**Marion County
Board of County Commissioners**

**PLANNING & ZONING SECTION
STAFF REPORT**

Public Hearing Dates	P&Z: 5/28/2025 Continued from 3/31/2025 after being continued from 1/27/2025	BCC: 6/16/2025
Case Number	250204SU	
CDP-AR No.	32615	
Type of Case: Special Use Permit	Utility company service yard including office building, warehouse, and outdoor equipment and material storage "lay-down yard."	
Owner	SECO Energy / Sumter Electric Cooperative, Inc. (previously Southern Hills Limited, Inc., Nan P. Bonfield, and Bryan Laura Trust)	
Applicant	Victoria Diaz, Bowman	
Street Address	12644, 12830, and 12940 SW 16 th Avenue	
Parcel Number	41200-012-00, 41200-020-00, and 41200-020-01	
Property Size	±39.20, ±20.00, and ±20.00 acres, totaling ±79.20 acres	
Future Land Use	Employment Center (EC)	
Zoning Classification	Community Business (B-2) [Based on an approval for Zoning Case No. 250203ZC representing ±39.20 acres of the ±79.20-acre site.]	
Overlays Zones & Special Areas	Outside Urban Growth Boundary (UGB), Marion Oaks/I-75 & Hwy 484 Urban Area, Secondary Springs Protection Zone (SSPZ), Marion County Utilities SW Service Area, and CR 475A Visual Enhancement Gateway Development Over

Figure 6
Concept - Site Plan

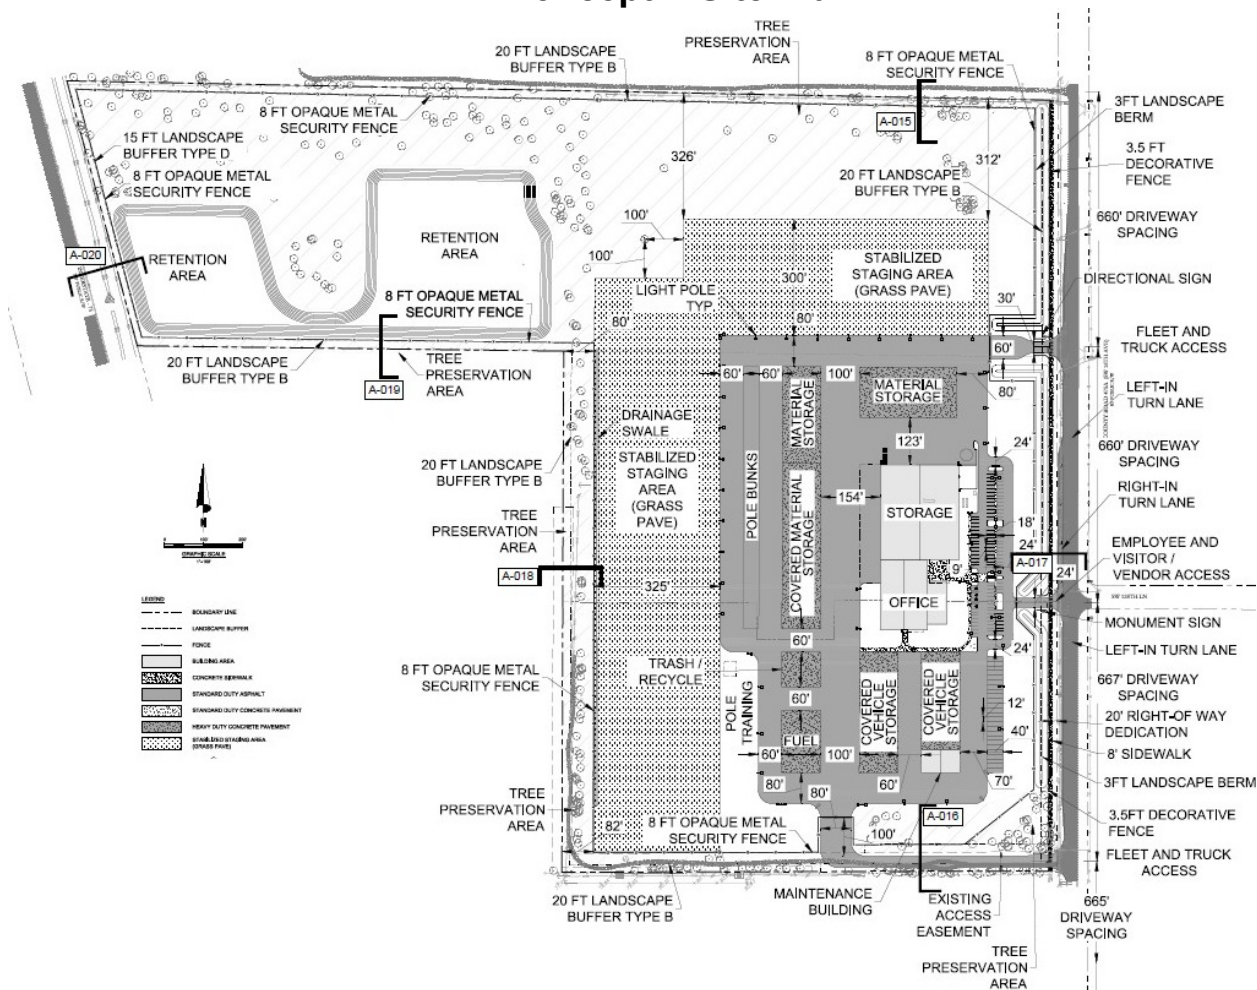
Three site access points are proposed. One employee and visitor/vendor access will be provided in the general center of the site with a driveway access point that aligns with SW 128th Lane. Fleet & truck entrances will be provided at the north and south ends of the facility. The south fleet & truck access point will incorporate the existing SW 130th Street Road access alignment and continue to provide access to the set of historic parcels

south/west of the site. Vehicles accessing the site will turn off the improved SW 130th Street Road to enter the site through a gated entrance, while traffic for the historic parcels will then continue west.

The concept plan illustrates various parking areas and covered parking structures, along with sizeable on-site vehicle aisles that will be provided to support SECO vehicles and the necessary movements of products and materials around the "lay-down" yard. The concept plan notes the opaque 8-foot high security fencing, proposed in lieu of a wall, will also serve to control site access, and the placement of gates will need to comply with LDC requirements to ensure vehicles do not obstruct CR 475A traffic when queuing at the gates as well as providing for emergency access for emergency services. As previously noted, the preliminary Traffic Study indicates turn-lane improvements will be required at the access points, that may also serve to address queuing concerns.

The proposed SECO facility will include a significant outdoor storage “lay-down” yard that will be predominantly be paved, except for the specialized, pole bunk area, while an auxiliary stabilized staging area for overflow parking and equipment during emergency responses will be also be provided. Such areas are a potential concern as frequent use may lead to generating dust and noise as vehicles and equipment are delivered, removed, or re-arranged on the site which will generate noise as well with the site’s active access. Additionally, as a primary facility, the areas may be accessed at various times, including in the evening and/or overnight in the event of outages and/or emergency situations that may create significant light/glare impacts from the site. *The isolated enclave area to the south/west is a concern should the placement of walls and/or berms and vegetation fail to adequately screen the activity and serve to block noise, light, sound, and potential windborne dust/debris from the site, particularly as the vegetation currently present is limited, and newly installed vegetation will require time to “grow-in” to establish a proper screening effect. Sufficient irrigation of these buffers to ensure their expeditious growth and maturity will be a critical concern along with their complete installation before site operations begin.*

7. The proposed office, warehouse, and covered vehicle parking shall be placed consistent with the SUP Conceptual Plan Set wherein the office aligns with the site's central access aligning with SE 128th Lane (identified as "Employee and Visitor/Vendor Access") and shall be designed and constructed in a manner consistent with the following standards:

- a) The office and warehouse shall be a single structure with varied vertical elevations consistent with the Community Business (B-2) Zoning height standards, and present visually as a fully enclosed structure with no bay doors or loading docks visible to CR 475A; and

- b) The office and warehouse shall not be a metal/corrugated siding or similar industrial appearance and shall present a façade varied in depth and finish in to avoid presenting a uniform monolithic appearance to CR 475A.

Figure 7
Concept – Landscape Plan

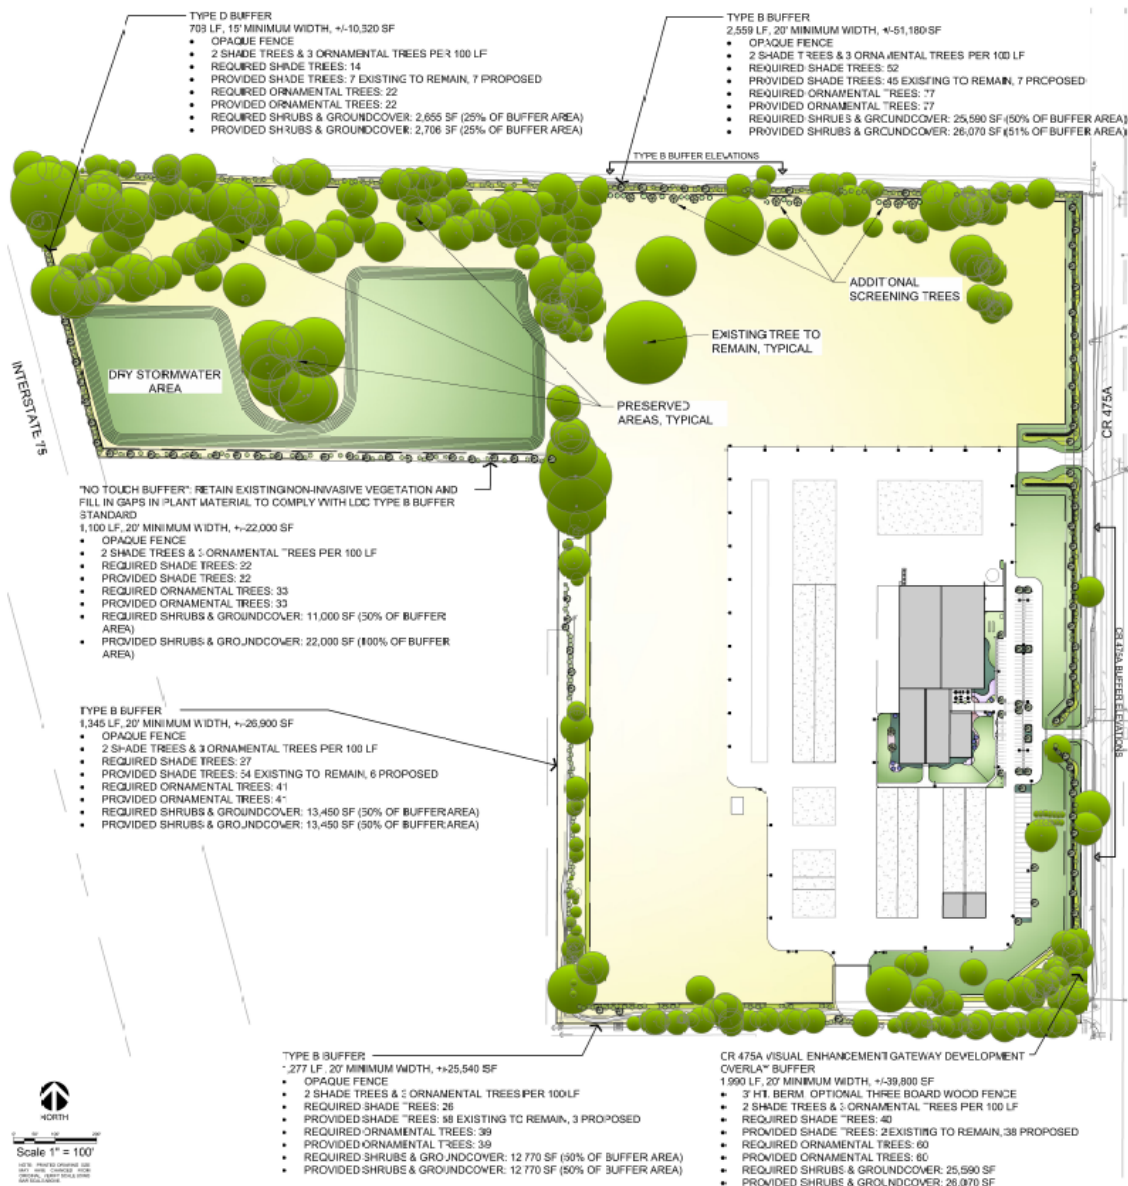
The submitted Concept Landscape Plan proposes a series of buffers along the site's boundaries based on the adjoining uses. The buffers are illustrated on the general site plan and landscape plan, with the site plan providing cross-section markers that reference the page numbers in the aerial & buffer exhibit that illustrate the buffers.

Along CR 475A, a berm topped with the required Type "C" Buffer, widened to 20-feet rather than 15-feet as required by the CR 475A Overlay, is indicated. The plan notes the provision of 3-foot high decorative board fence within the buffer as supported by the CR 475A Overlay; further, an 8-foot high opaque metal fence with green metal and trim finish is proposed on the far internal side of the CR 475A buffer, and that same opaque fence will extend around the full site.

The immediately adjoining properties to the north, and the isolated enclave properties to the south/west, are either developed with single-family homes and/or in agricultural use with General Agriculture (A-1) zoning. Commercial use of the site is required to provide a B-Type Buffer to single-family uses and a D-Type Buffer to agricultural uses; both the B-Type and D-Type Buffers require the provision of a minimum 6-foot high wall along the interior side of the buffer. *In lieu of the required wall, the plan proposes the noted 8-foot high opaque metal fence with green metal and trim finish for the buffer walls.* The buffer requirements for each boundary are summarized below, wherein compliance with the applicable design standards is proposed, except for the noted replacement of the required wall with the *8-foot high opaque metal fence*:

- 1) North boundary - 20-foot wide B-Type Buffer; *however, the plan proposes an opaque security fence in lieu of a wall*, along with an area of open space approximately 300-feet in depth south of the buffer.

- 2) West boundary shared with I-75 (north parcel of the site) - 15-foot wide D-Type Buffer; *however, the plan proposes an opaque security fence in lieu of a wall against the planned DRA.*

- 3) South boundary (north parcel of the site) - 20-foot wide B-Type "No Touch Buffer" with vegetation added to meet the Type "B" Buffer vegetation standards; *however, the plan proposes an opaque security fence in lieu of a wall against the proposed DRA.*

- 4) South boundary (corresponds to SW 130th Street Road) - 20-foot B-Type Buffer; *however, the plan proposes an opaque security fence in lieu of a wall.*

- 5) West boundary (north project of SW 130th Street Road shared with the isolated enclave parcels) - 20-foot wide B-Type "B" Buffer; *however, the plan proposes an opaque security fence in lieu of a wall.* Staff notes that for this boundary location, the site is expected to be elevated above the existing off-site grade levels, so the site and the outside equipment and materials storage will be "above" the adjoining residential properties to the west. Currently, that shared boundary features limited vegetation, and while plantings will be provided, lighting from that area is a concern due to its elevated position. *The applicant has proposed that all site lighting will comply with LDC Division 6.19 - Outdoor Lighting, and has agreed to comply with "Dark Sky" principles in response to Attorney Batsel's March 29th letter.*

In regards to the proposed structures, a conceptual Aerial & Buffer Exhibit with a view of the overall facility was provided, providing buffering illustrations for along CR 475A the buffer at installation, 3-years, and maturity, wherein the illustrations show the proposed office/warehouse facility. Staff notes that the proposed warehouse portion of the complex would remain visible CR 475A, even at maturity, and the warehouse will extend ± 250 parallel to the roadway. *The visual appearance of that structure is a concern to ensure it does not have an intrusive monolithic appearance that is not supportive of the visual interest outlined for the CR 475A Overlay.*

4. All buffers and boundaries shall include those improvements depicted or noted on the SUP Conceptual Plan Set and accompanying documents and complying with the following:

- a) The site shall include the 8-foot opaque security fencing and gates, as shown in the SUP Conceptual Plan Set, that shall be provided around the entire property as indicated,

- b) B-Type Buffers shall consist of a 20-foot landscaped strip and an eight-foot (8') opaque security fence. The landscaped strip shall contain at least three shade trees and five accent / ornamental trees for every 100 lineal feet or fractional part thereof. Shrubs and groundcovers, excluding turfgrass, shall comprise at least 50 percent of the required buffer area and shall form a layered landscape screen with a minimum height of three feet within one year of planting.

- c) The B-Type Buffer along the west side of subject property's two southern parcels, adjoining off-site PID#s 41200-011-00, 41200-023-00, and 41200-024-00, shall be provided as indicated, subject to the following:

- 1) At the time of planting/installation, a minimum of 1/3 of the shade trees and 1/5 of the accent/ornamental trees shall be increased in size at the time of planting to be 25% above the minimum planting size as specified by the LDC.

- 2) The 8-foot opaque fencing along this west boundary shall be installed at the outer perimeter of the outdoor storage "lay-down" yard areas as indicated in the SUP Conceptual Plan Set, and the minimum fencing height shall be based on, and measured from, the finished grade elevation of the adjoining outdoor storage "lay-down" yard areas, to screen those areas when their finished grades have been elevated in relation to the site's adjoining property lines.

- d) D-Type Buffers shall consist of a 15-foot landscaped strip and an eight-foot (8') opaque security fence. The landscaped strip shall contain at least three shade trees and five accent / ornamental trees for every 100 lineal feet or fractional part thereof. Shrubs and groundcovers, excluding turfgrass, shall comprise at least 25 percent of the required buffer area and shall form a layered landscape screen with a minimum height of three feet within one year of planting.

- e) CR 475A (modified C-Type) Buffer shall consist of a 20-foot landscaped strip and an eight-foot (8') opaque security fence. The landscaped strip shall contain at least two shade trees and three accent / ornamental trees for every 100 lineal feet or fractional part thereof. Shrubs and groundcovers, excluding turfgrass, shall comprise at least 50 percent of the required buffer area and shall form a layered landscape screen with a minimum height of three feet within one year of planting. In addition to the foregoing and as depicted on the SUP Conceptual Plan Set, the eastern boundary shall also include a three-foot (3') berm and decorative 3-board fence, pursuant to LDC Section 5.8.A, Figure 5.8.5-1.

- f) All berms and landscaping shall be constructed and maintained in a manner compliant with the Land Development Code, preventing materials stored outdoors on the Property or any portion thereof used as a laydown yard from the viewshed of adjacent properties.

- g) All buffers, including berm(s) and landscaping, shall be constructed or installed prior to receipt of a final inspection for any building improvements constructed on the Property, and shall be maintained consistent with LDC requirements in perpetuity.

- h) All landscaping shall be served by an irrigation system installed, maintained, and operated in perpetuity by SECO.
 - i) SECO shall install six-foot (6') opaque construction fencing around the entire Property during construction.
